NOTICE OF ADDENDUM

ADDENDUM NO. 2

CITY OF MADISON
NAKOOSA TRAIL FLEET/FIRE/RADIO SHOP FACILITY

G-003

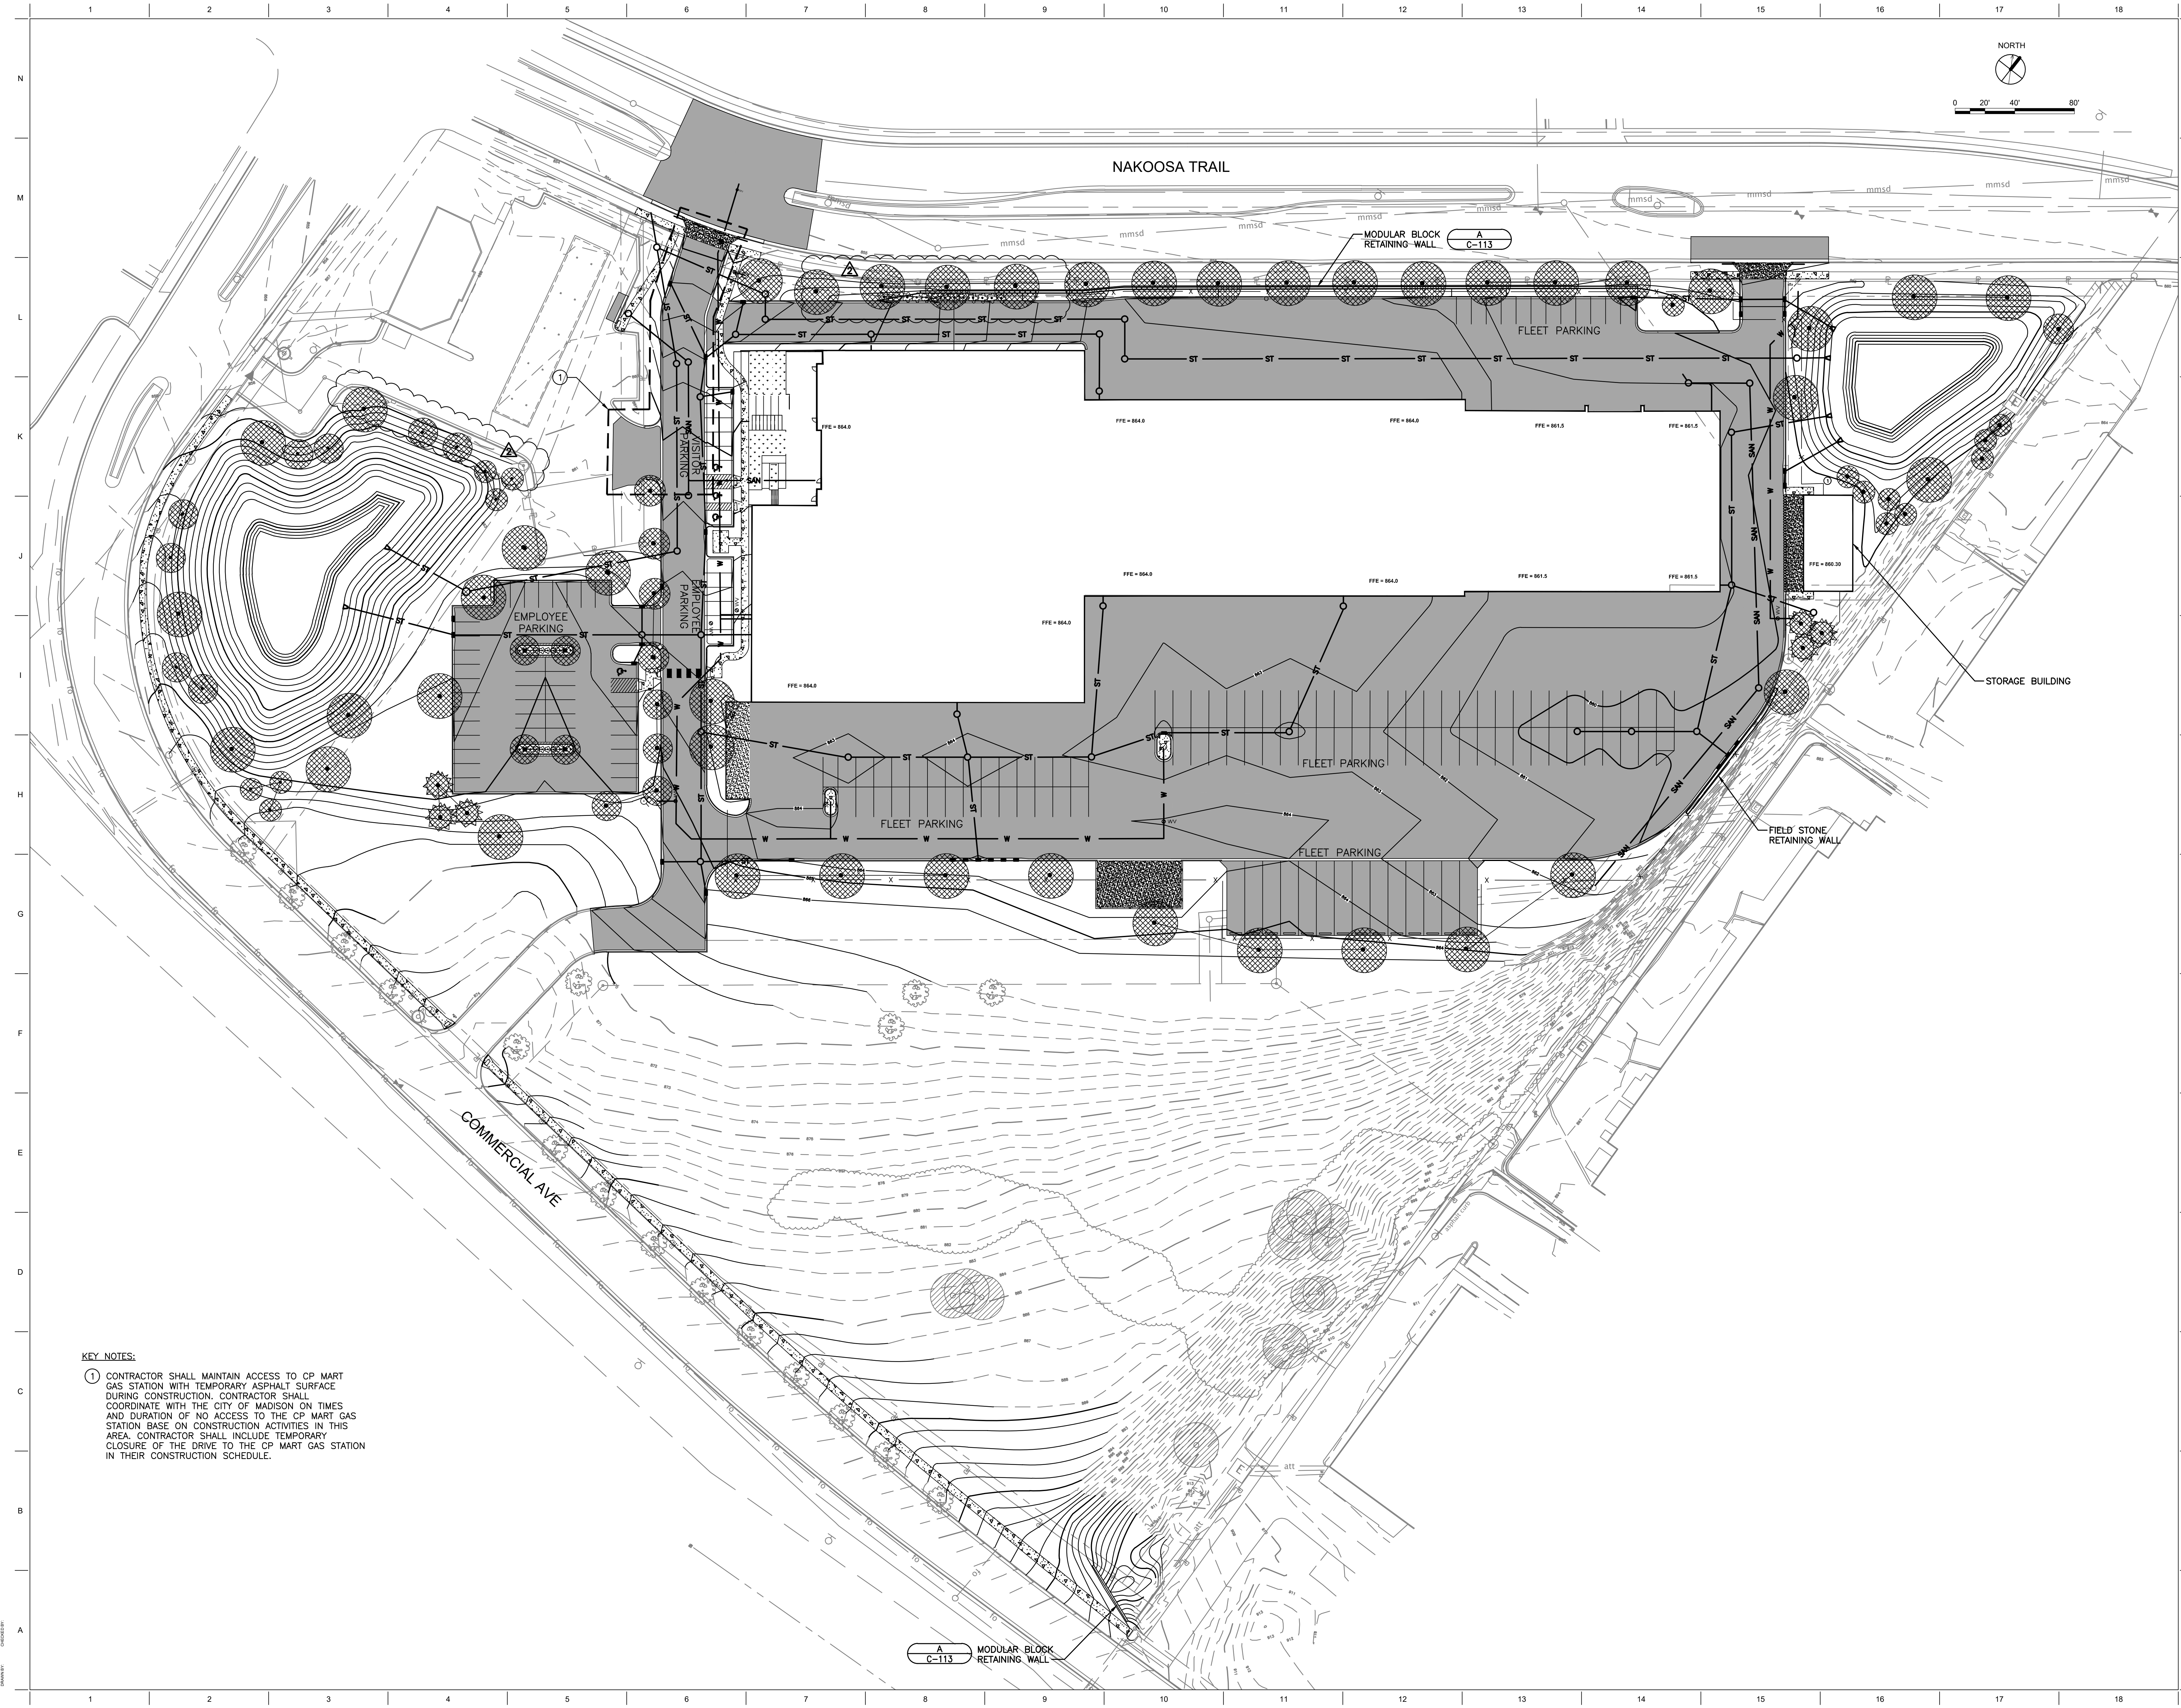
- A. **MODIFIED** G-001 COVER SHEET to update overall building & site rendering.
- B. **MODIFIED** G-003 CODE AND LIFE SAFETY INFORMATION to shift locations of Fire Extinguishers.

C-100

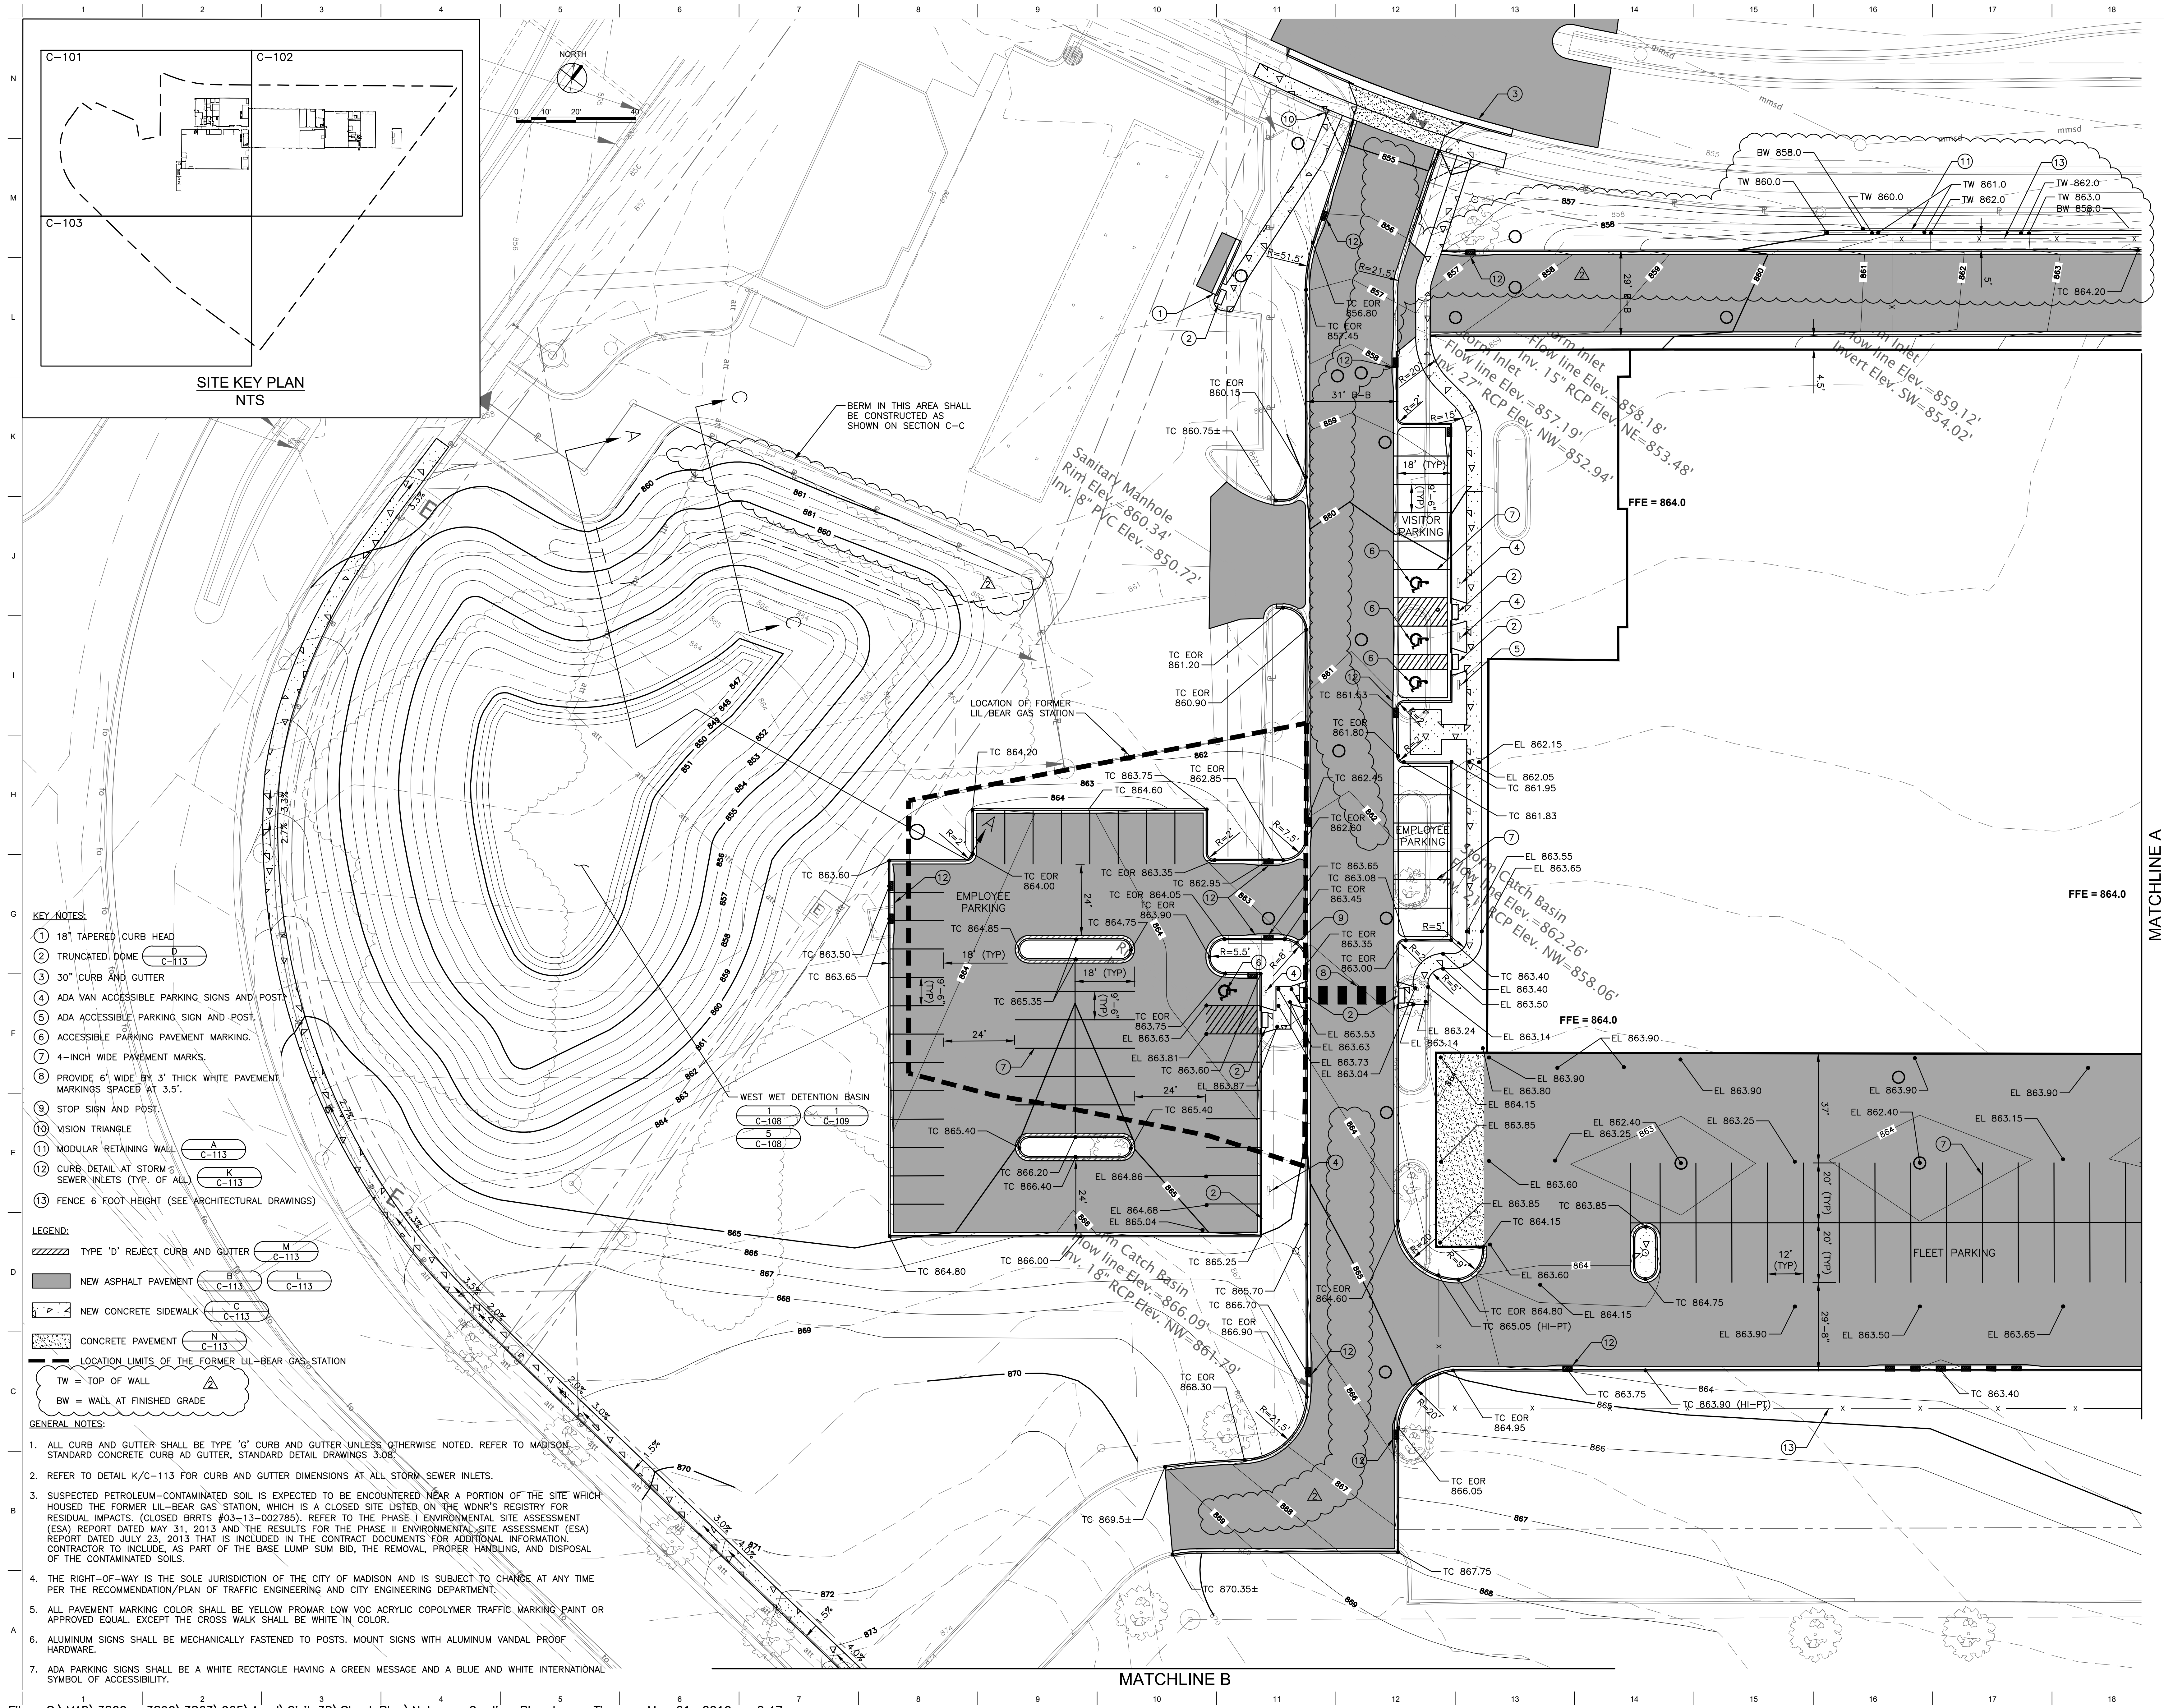
- C. **MODIFIED** C-100 OVERALL SITE PLAN to include grading at the western detention basin and removal of the western end of the modular block retaining wall along Nakoosa Trail.

C-101

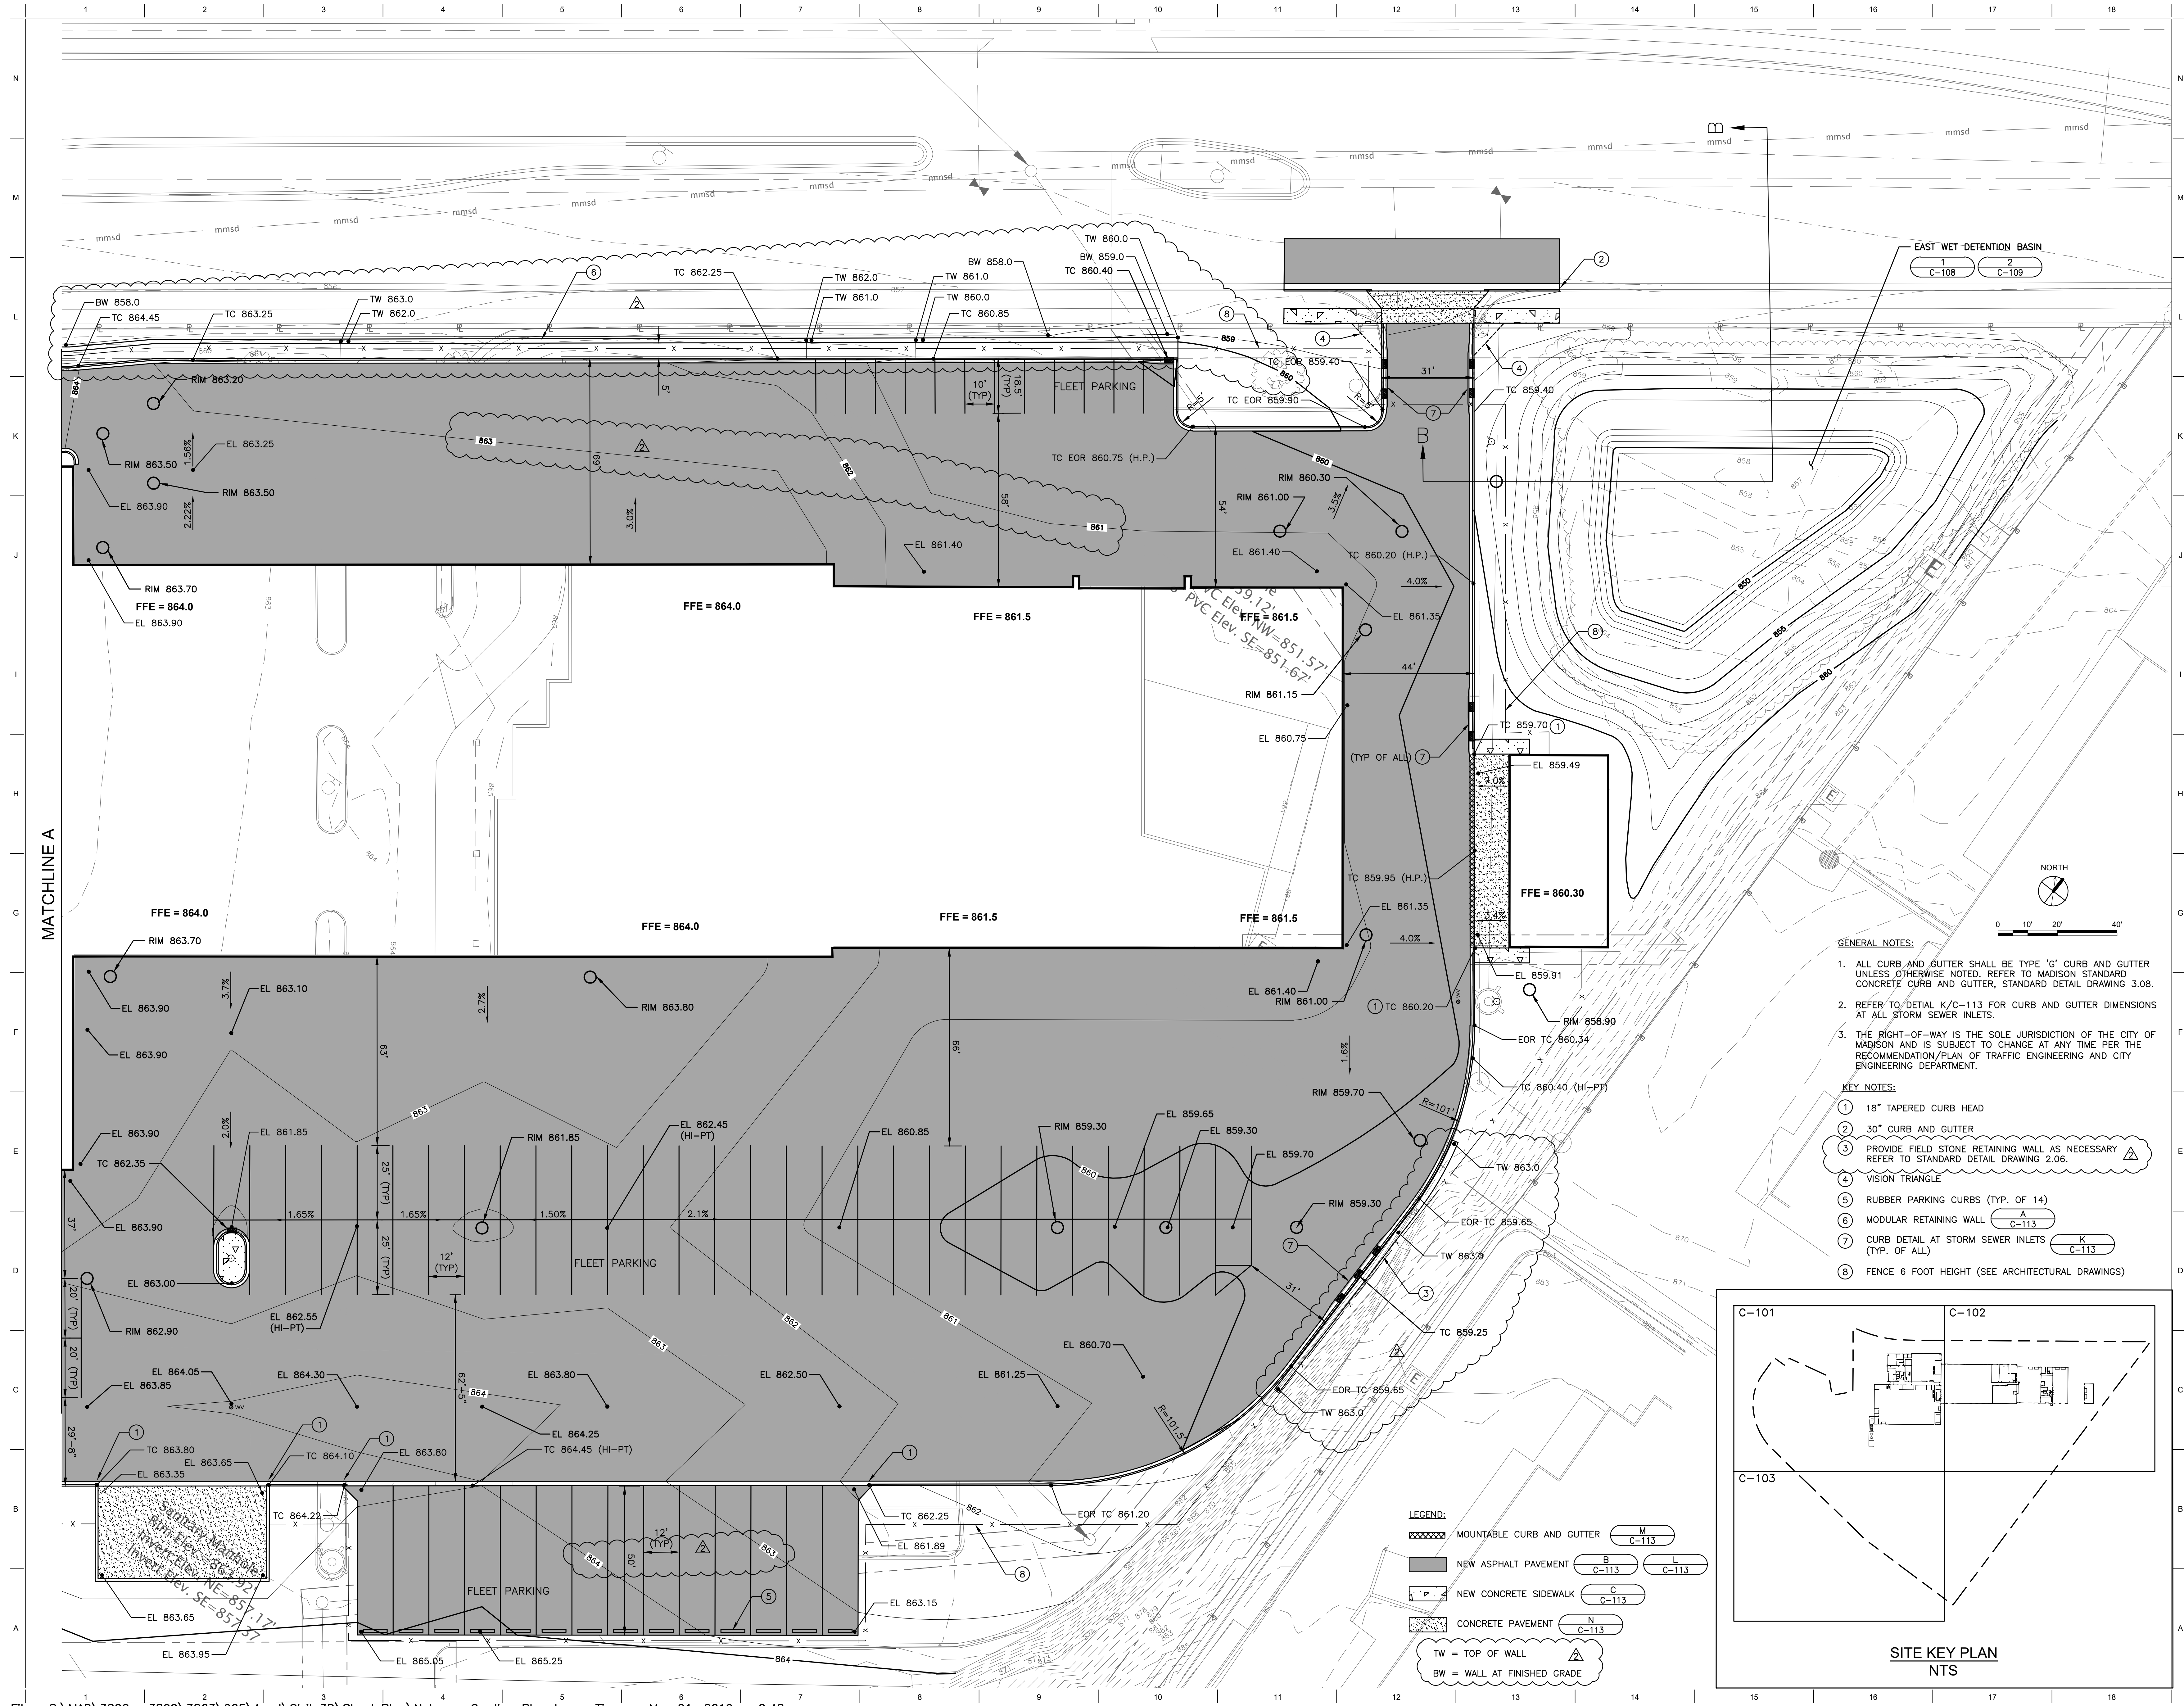
- D. **MODIFIED** C-101 SITE PLAN to include grading at the western detention basin, removal of a portion of the western end of the modular block retaining wall and revision to elevations along Nakoosa Trail, labeling of contours on the drawing, and an addition to the Legend.
